ADMINISTRATIVE AMENDMENT

PROJECT NUMBER: PR-2018-001670
 Application Number: SI-2019-00181
 Is an Infrastructure List required? () Yes () No. If yes, then a set of approved DRC plans with a work order is required for any construction within Public Right-of-Way or for construction of public improvements.
 DRB SITE DEVELOPMENT PLAN SIGNOFF APPROVAL:

PROJECT NAME: U-HAUL STORAGE OF WESTSIDE
 MUNICIPALITY: CITY OF ALBUQUERQUE
 PROJECT ADDRESS: 2217 4TH ST. NW ALBUQUERQUE, NM 87102
 ACRE / AREA: 2.5 ACRES / 108,900 SF.
 ZONE: MX-M - MIXED-USE - MODERATE INTENSITY
 ADJACENT ZONING:
 N- MX-M - MIXED-USE - MODERATE INTENSITY
 E- MX-M - MIXED-USE - MODERATE INTENSITY
 S- INTERSTATE 40/ MX-M - MIXED-USE - MODERATE
 INTENSITY
 W- MX-M - MIXED-USE - MODERATE INTENSITY

EV-1

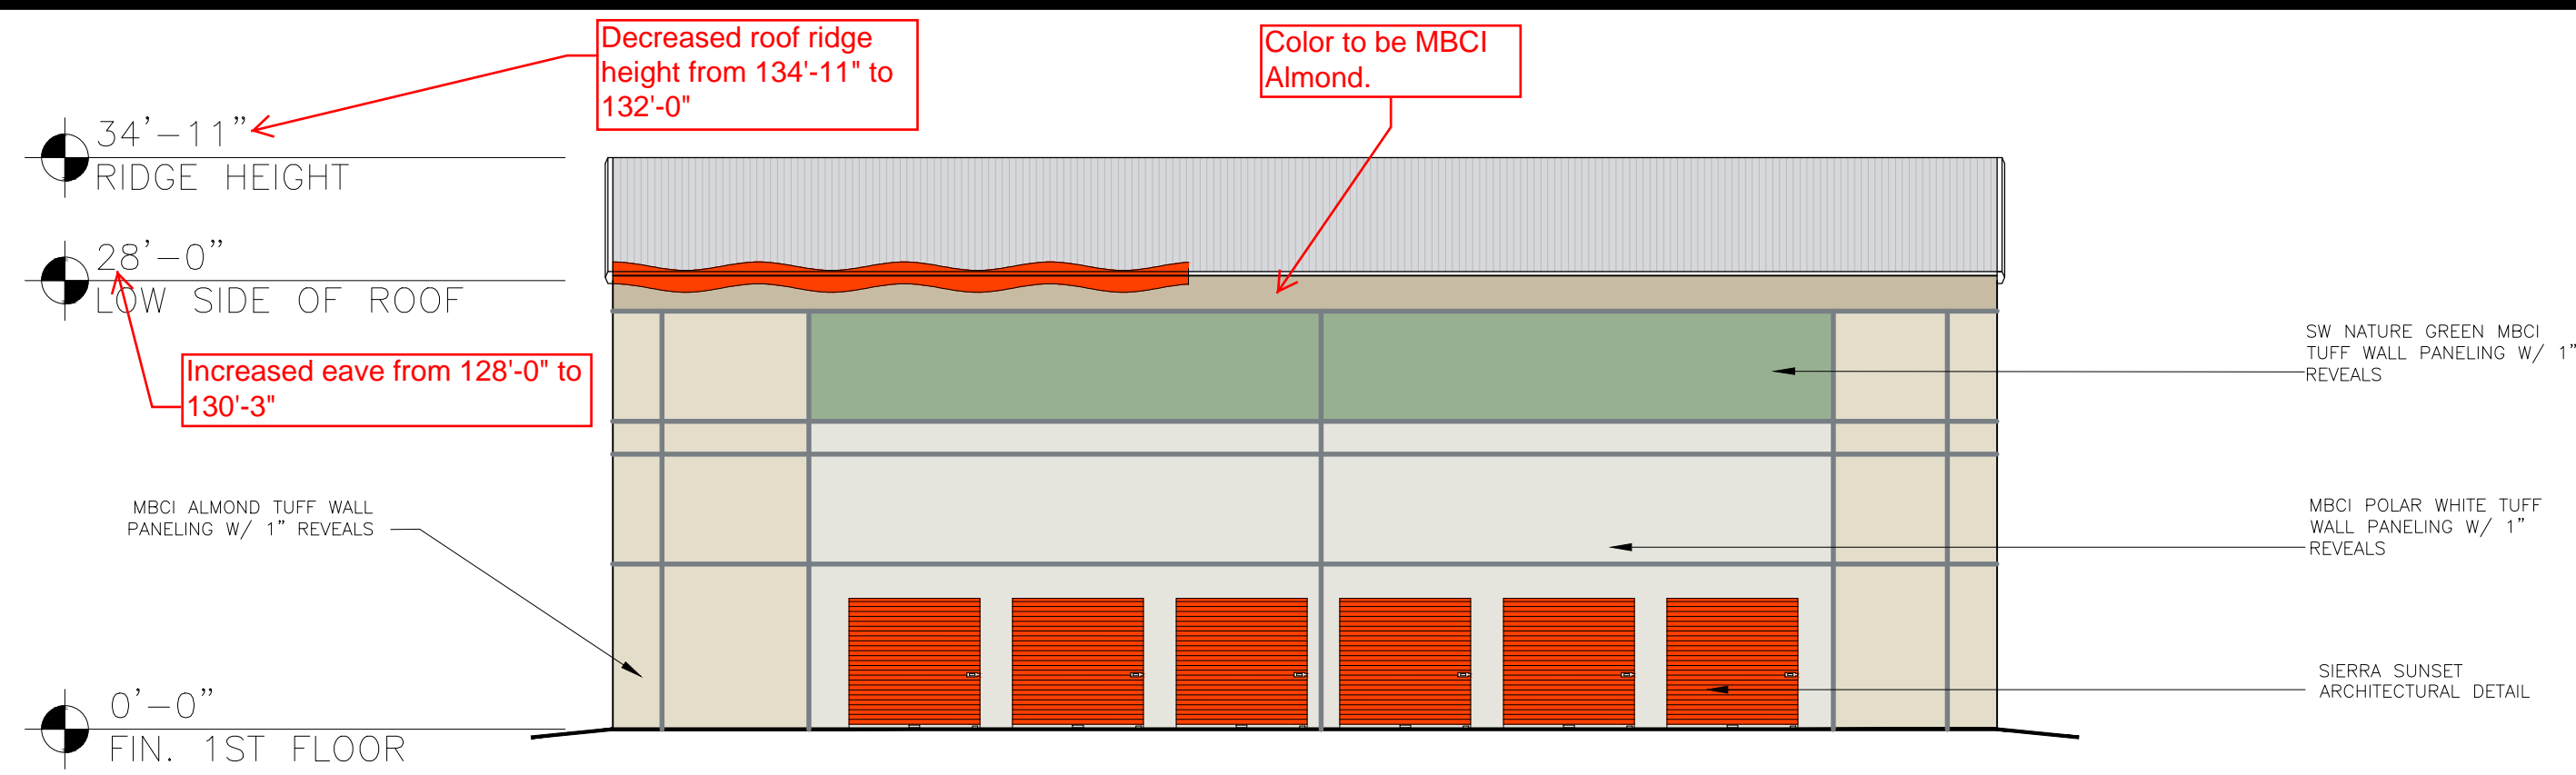
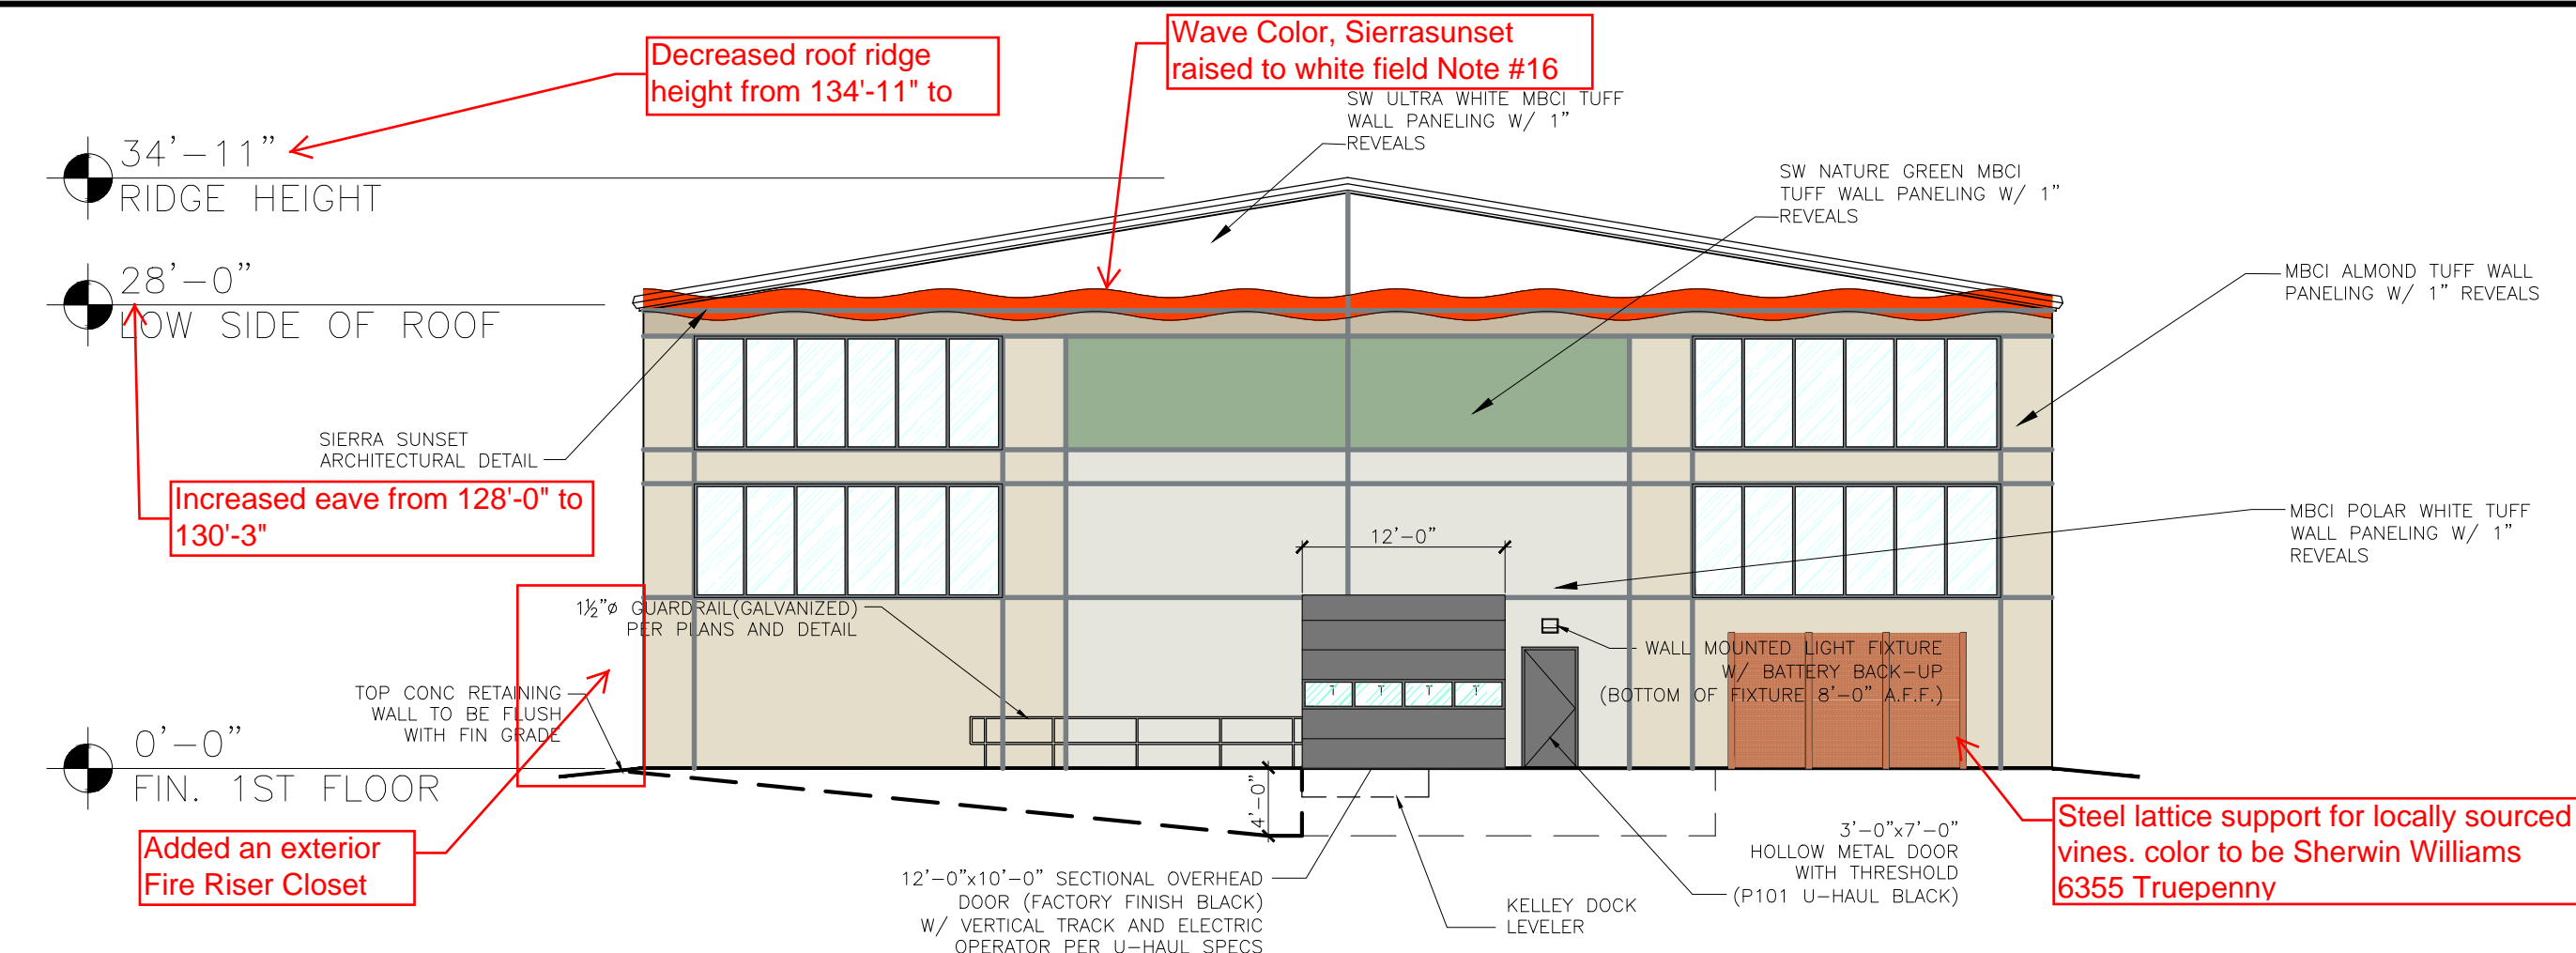
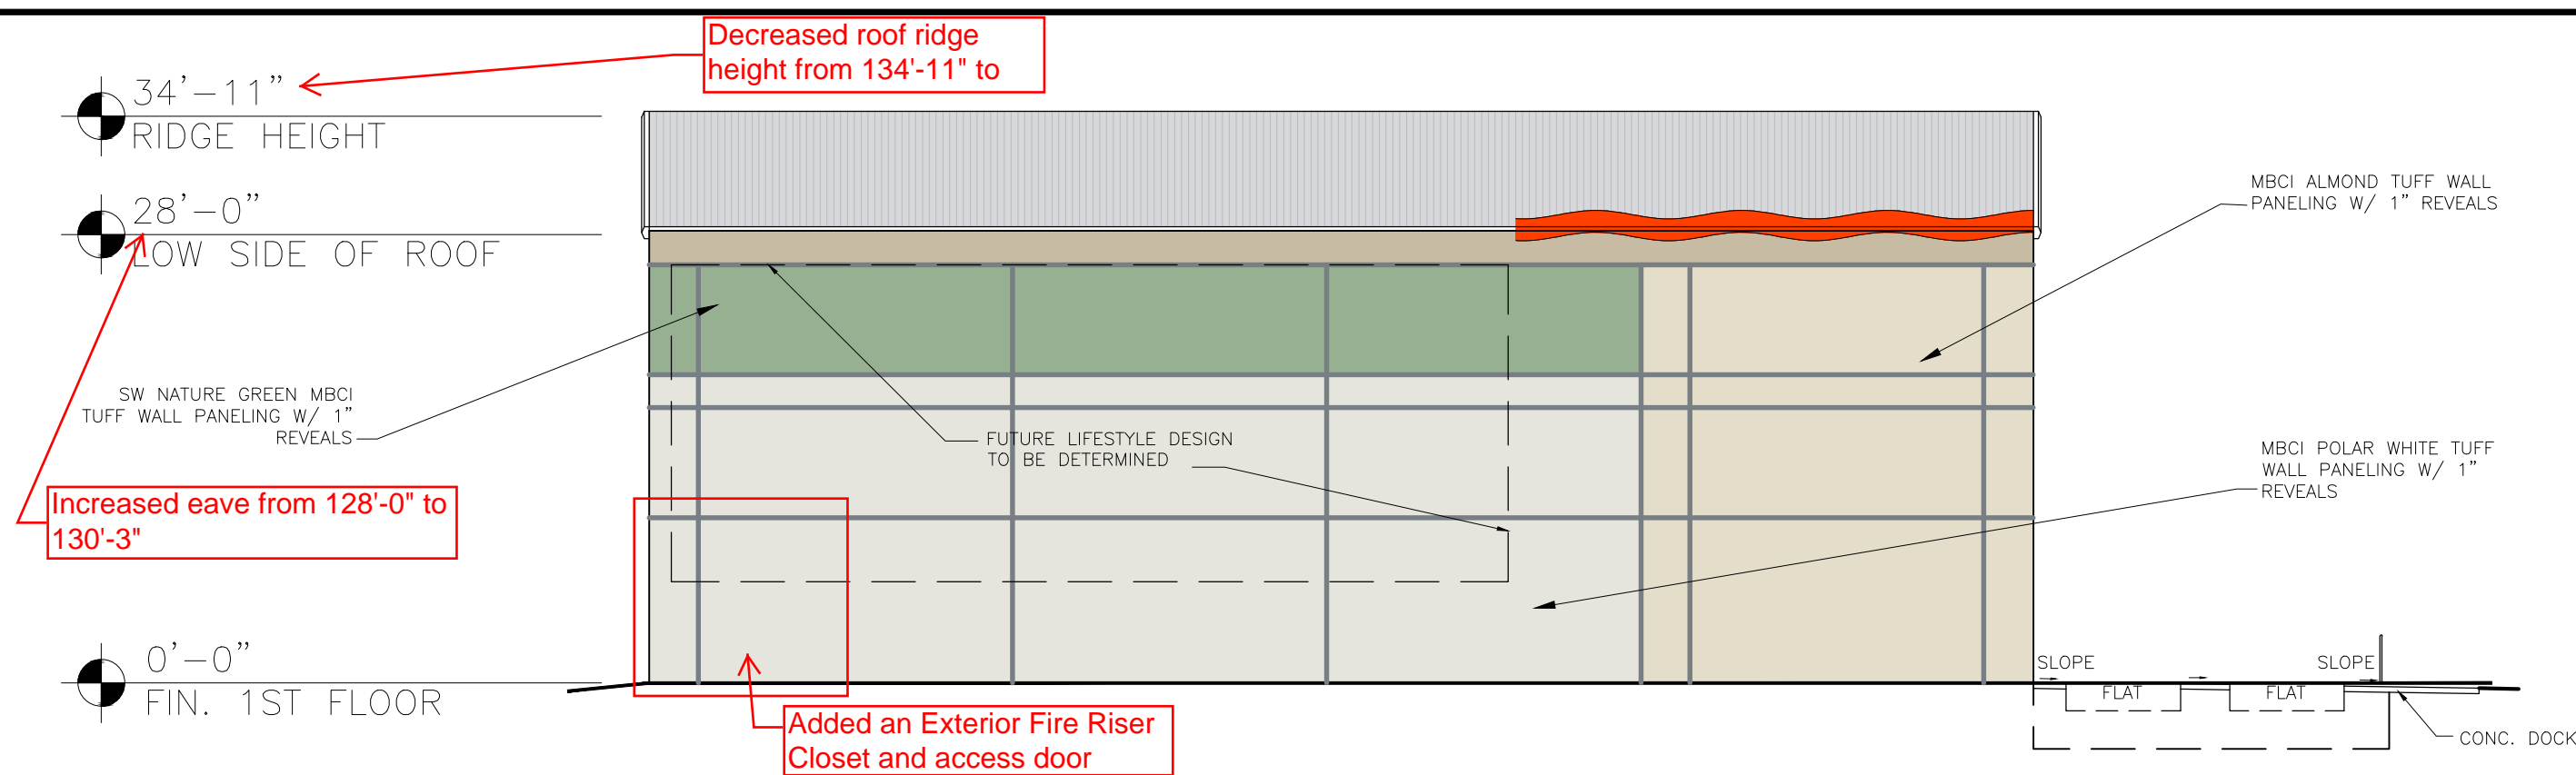
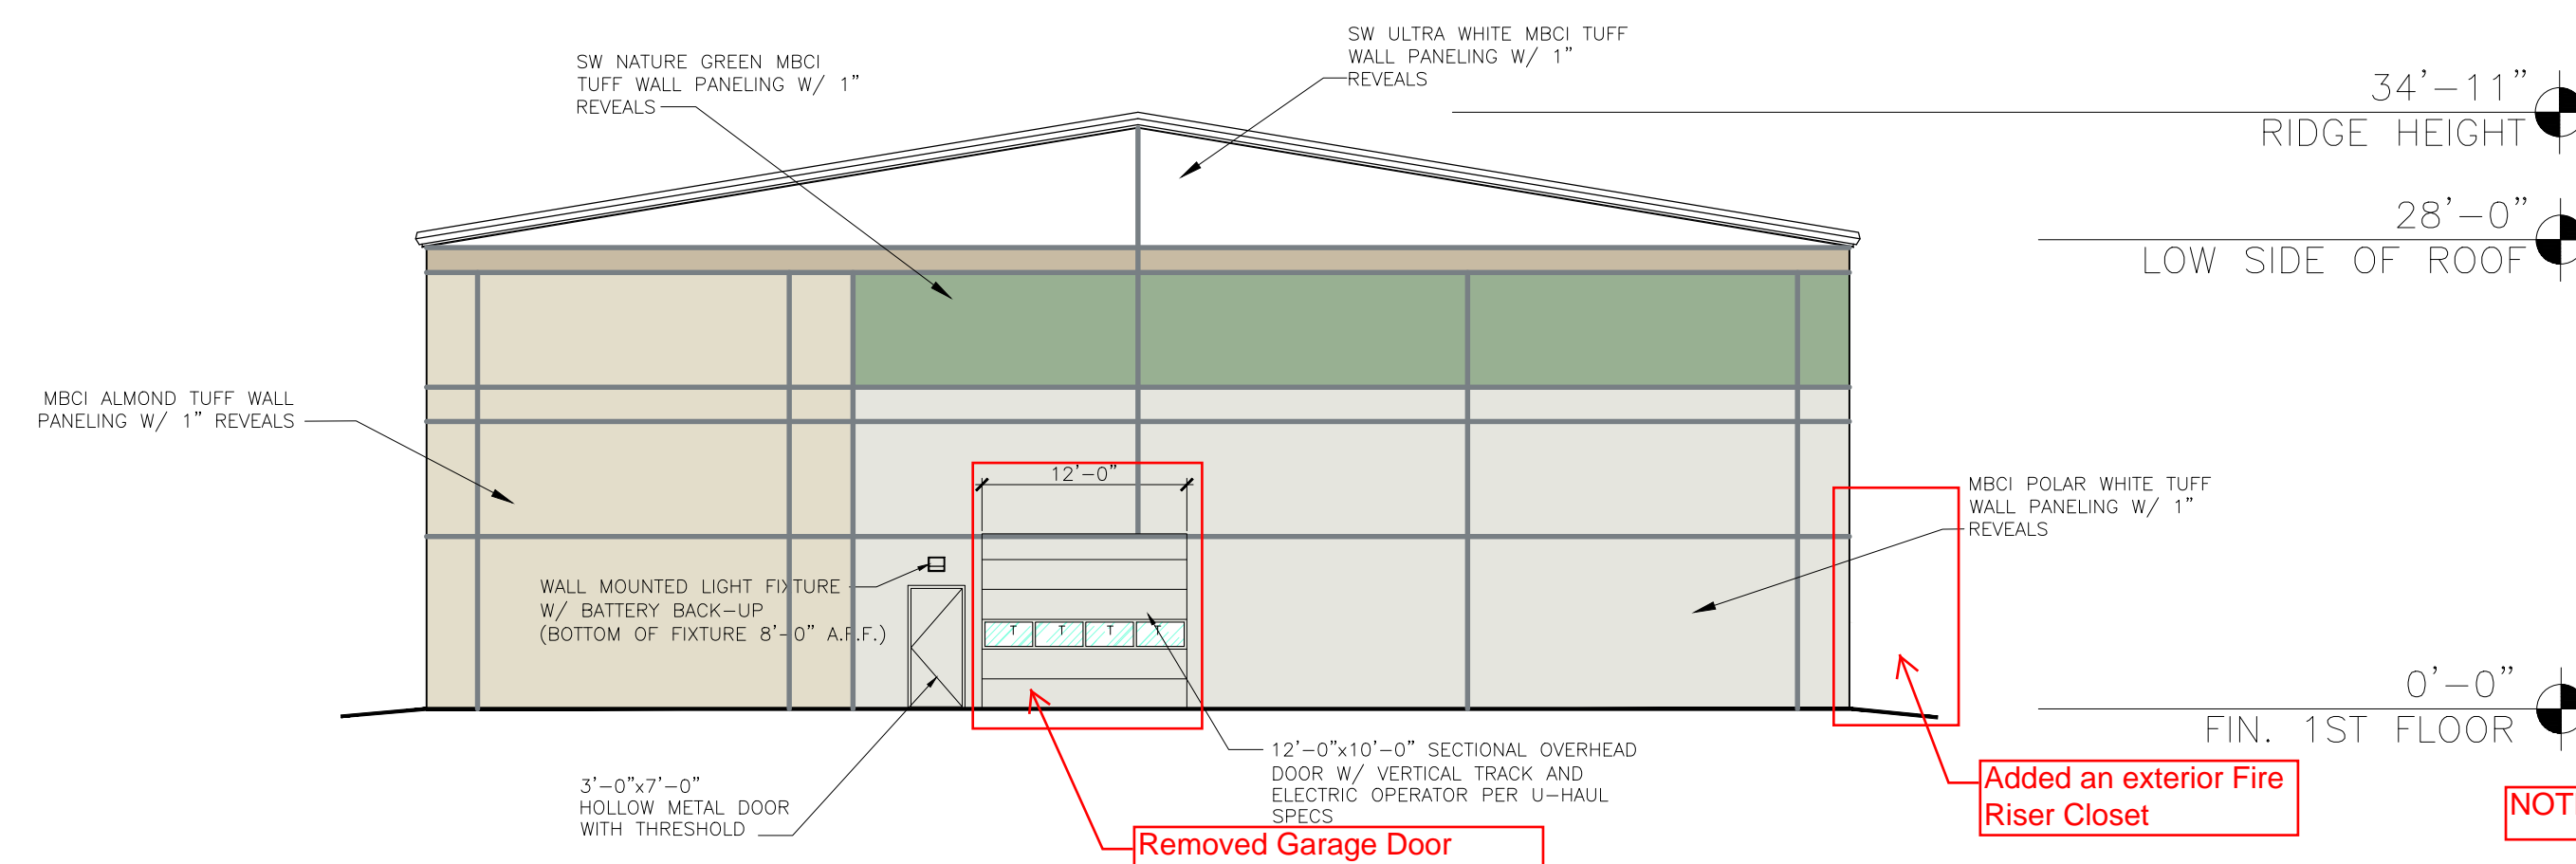
NOTE: SEE SHEET AB201 FOR NOTED REVISIONS

NOTE: SEE SHEET AB201 FOR NOTED REVISIONS

NOTE: SEE SHEET AB201 FOR NOTED REVISIONS

NOTE: SEE SHEET AB201 FOR NOTED REVISIONS
